**Subject: Submittal of ABWR Licensing Topical Report (LTR)  
NEDO-33336 "Advanced Boiling Water Reactor (ABWR)  
Stability Evaluation"**

Enclosure: NEDO-33336 "Advanced Boiling Water Reactor (ABWR)  
Stability Evaluation", June 2007 - Non-Proprietary

NEDO-33336  
Class I  
eDRF 0000-0064-3948  
June 2007

**LICENSING TOPICAL REPORT**  
**Advanced Boiling Water Reactor (ABWR)**  
**Stability Evaluation**

Tier 2 Figure 4.4-1 Power-Flow Operating Map Used for System Response Study

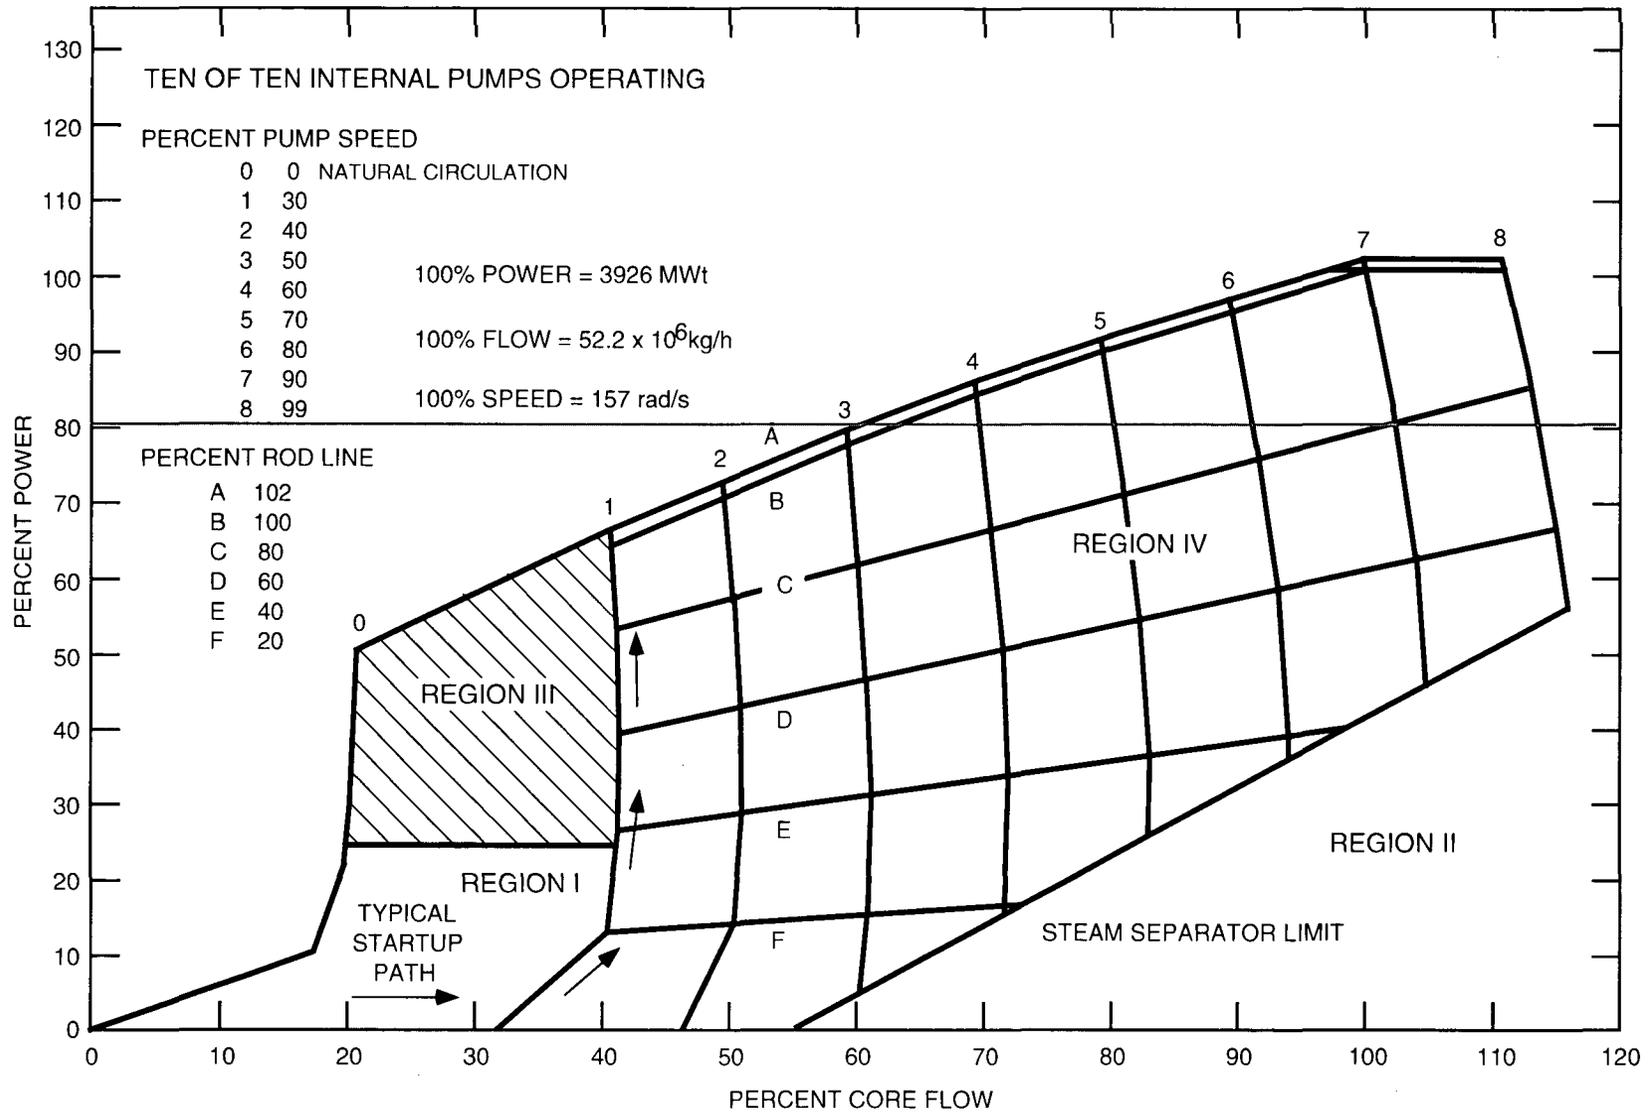
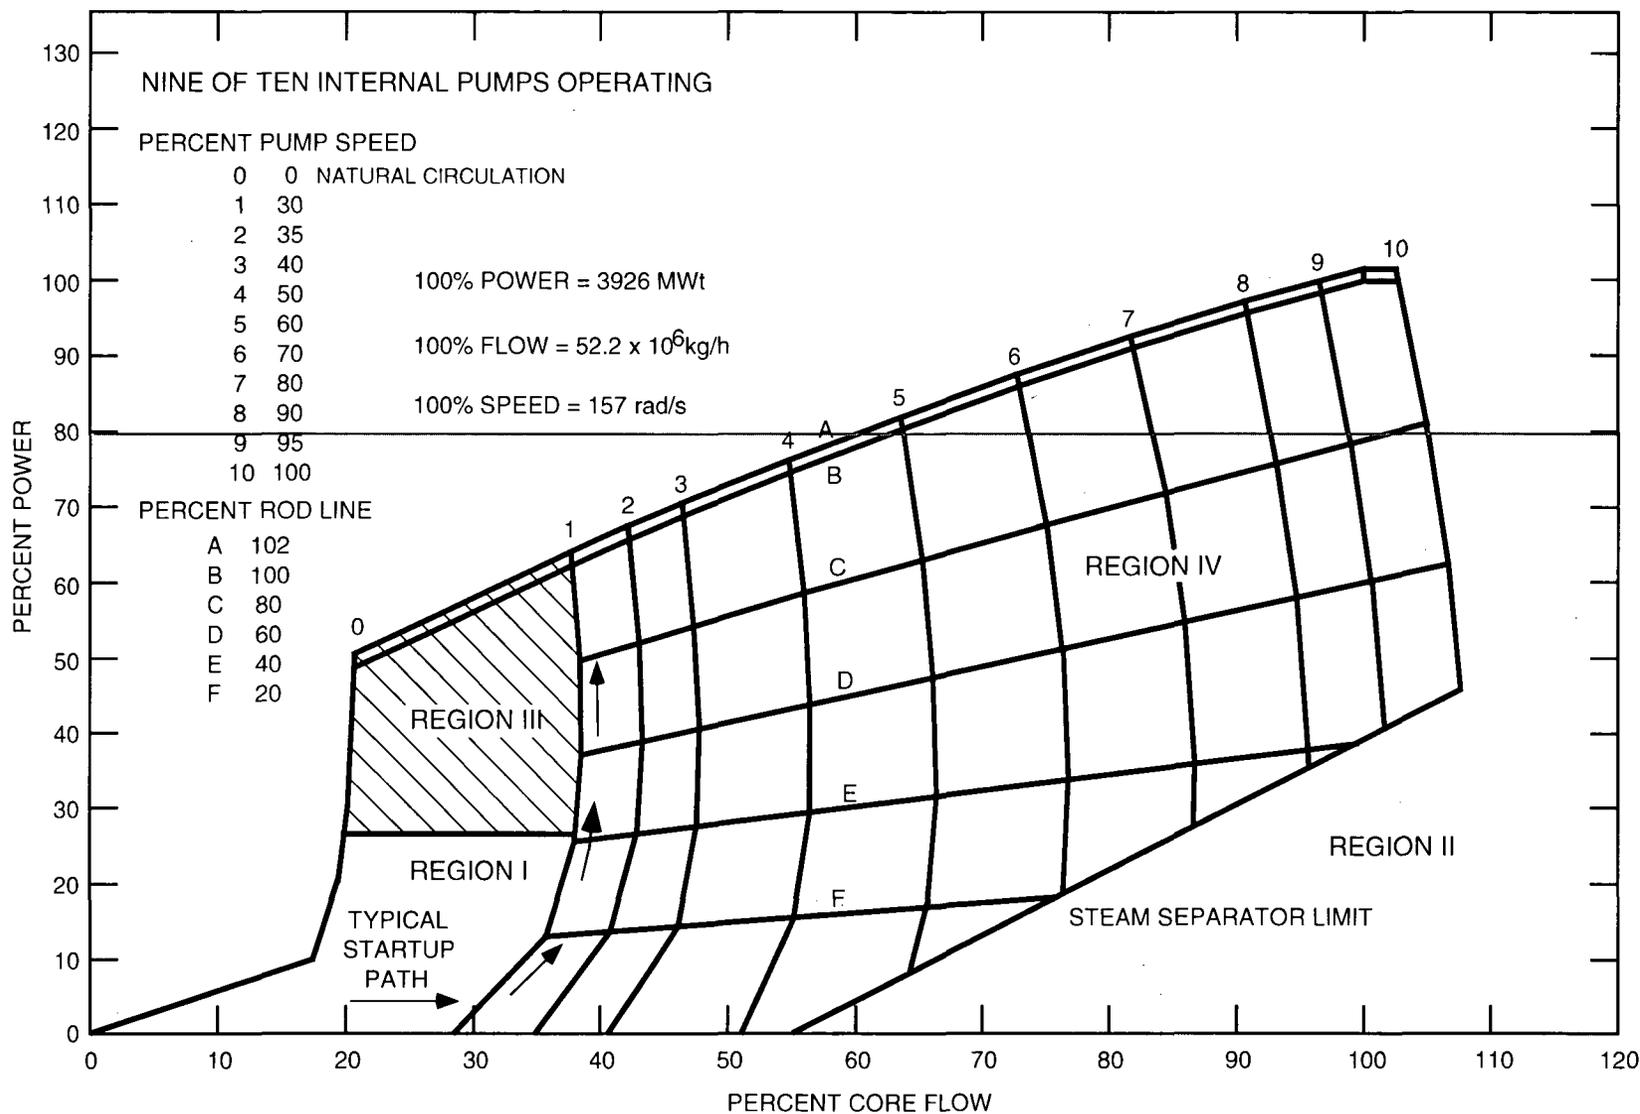
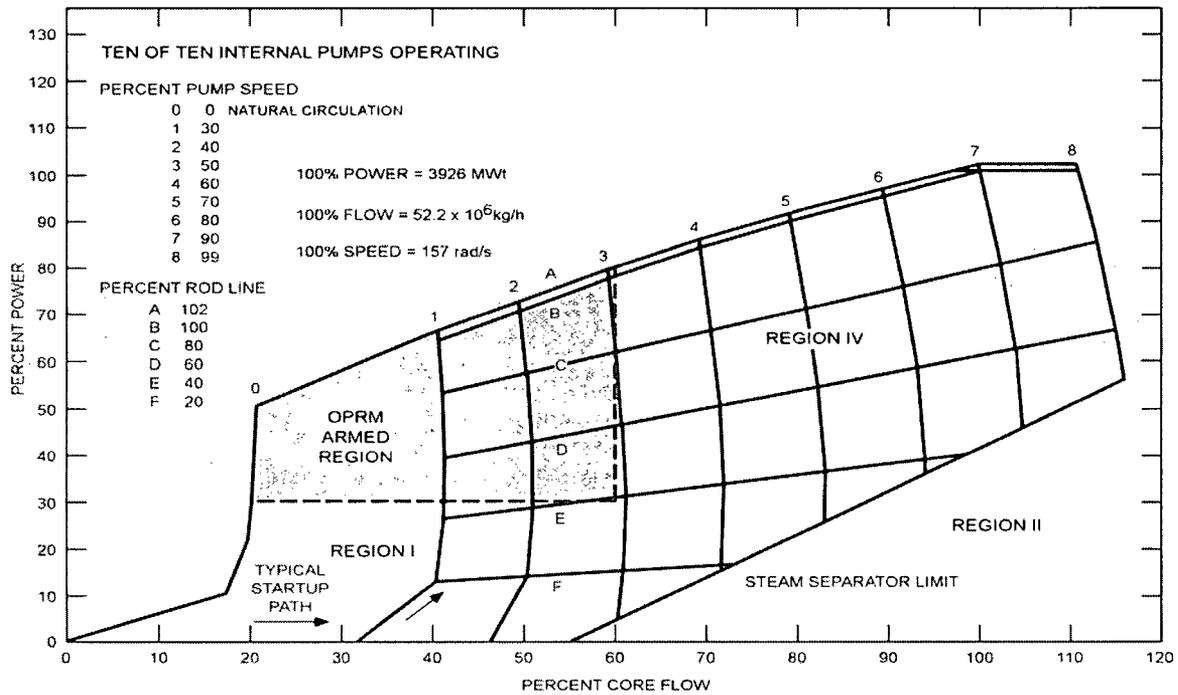
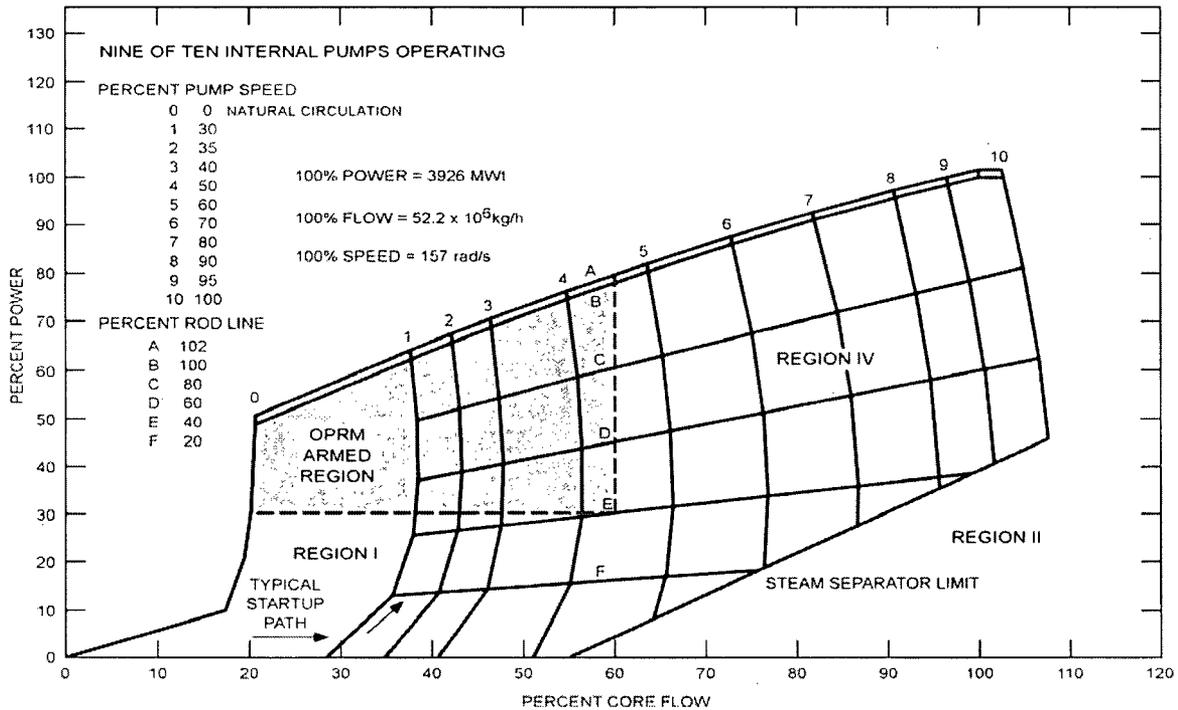
The DCD markups provided in Appendix C identify the specific changes proposed by this LTR. The proposed changes are at the same level of detail as the original DCD.

Tier 2 Figure 4.4-2 Power-Flow Operating Map Used for System Response Study  
(9 RIPs Operating)

Figure 4.4-4 Stability Controls and Protection Logic

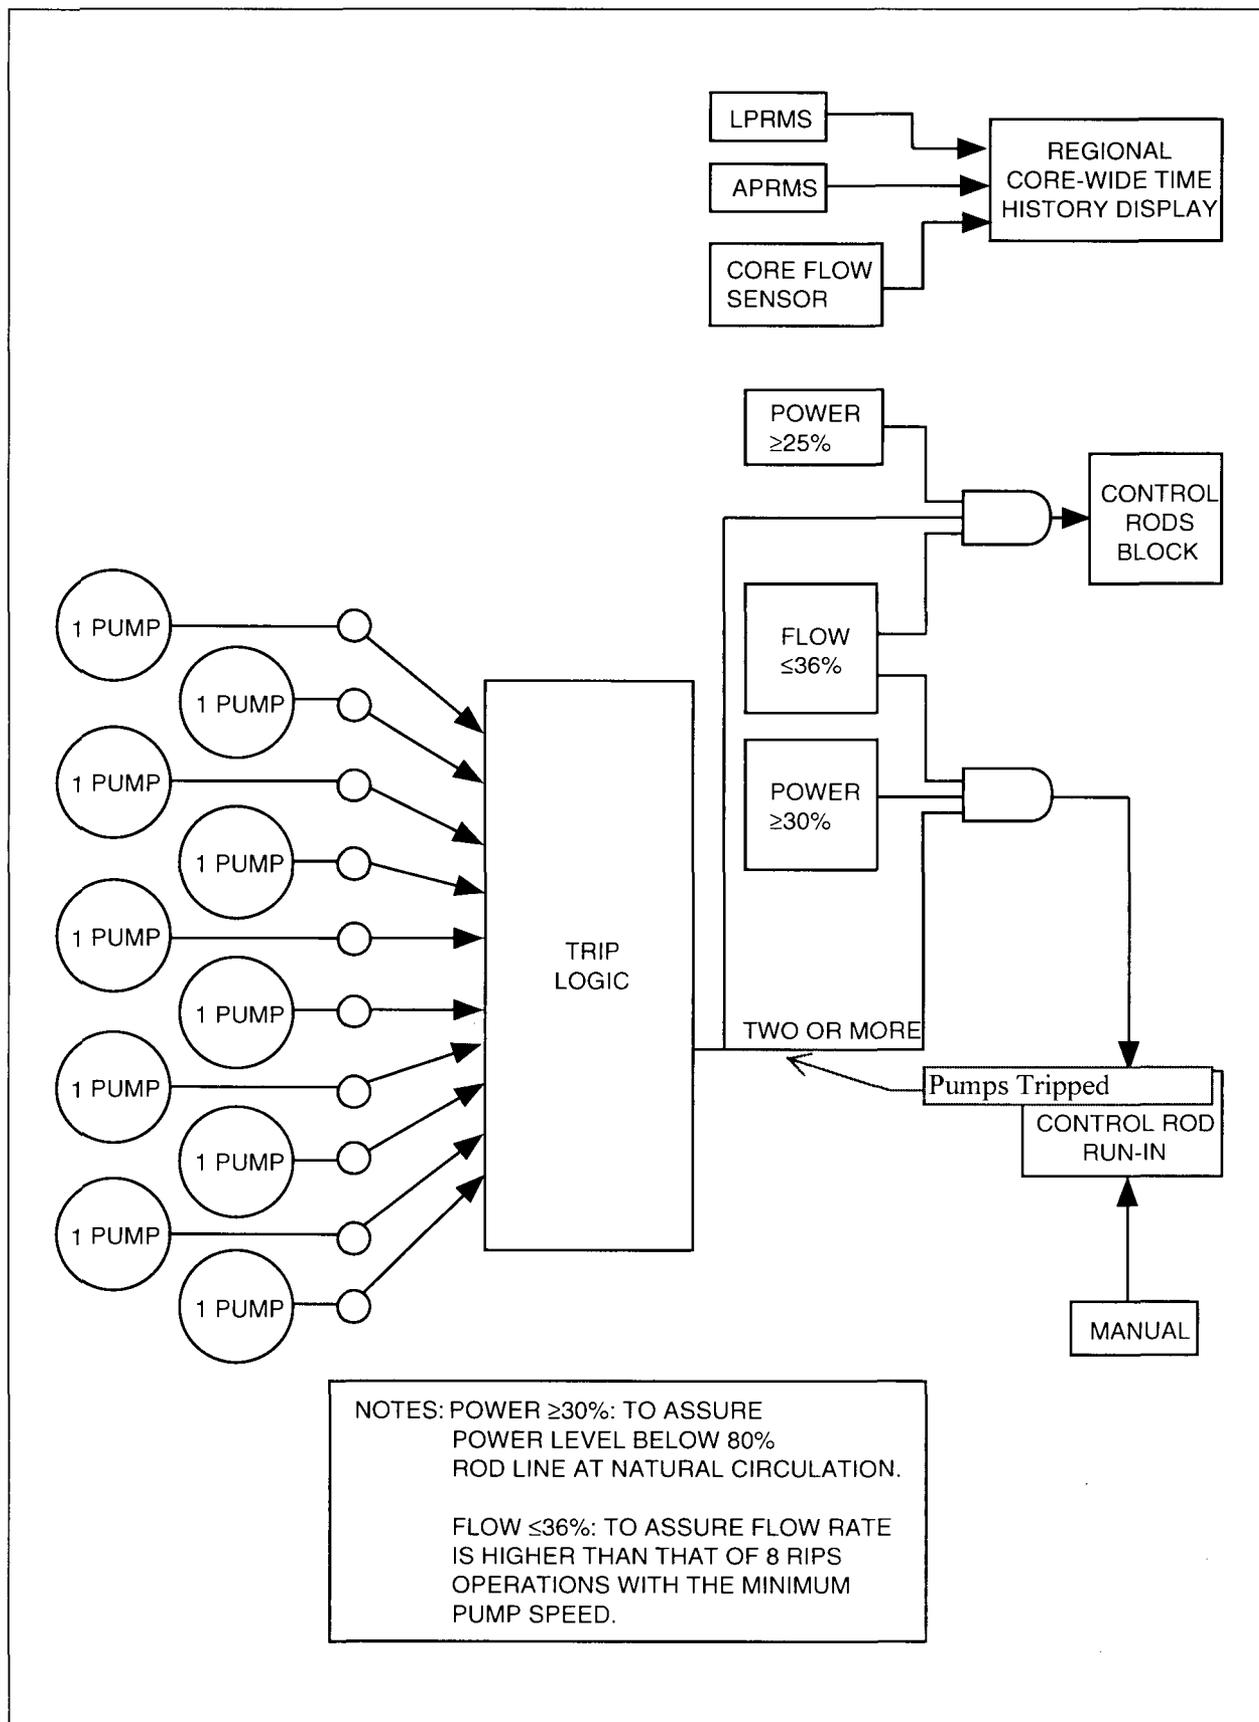
Tier 2 Figure 4.4-4 Stability Controls and Protection Logic

Furthermore, automatic logics (Figure 4.4-4) which prevent plant operation in the region with the least stability margin is also implemented. This design is similar to Option I-A, one of long-term solutions considered by the BWROG. In addition, in order to meet the stability design requirements specified in the ALWR Utility Requirements Document, Option III, LPRM based Oscillation Power Range Monitor (OPRM), which is also one of the long-term solutions considered by the BWROG, has been implemented in the ABWR design.
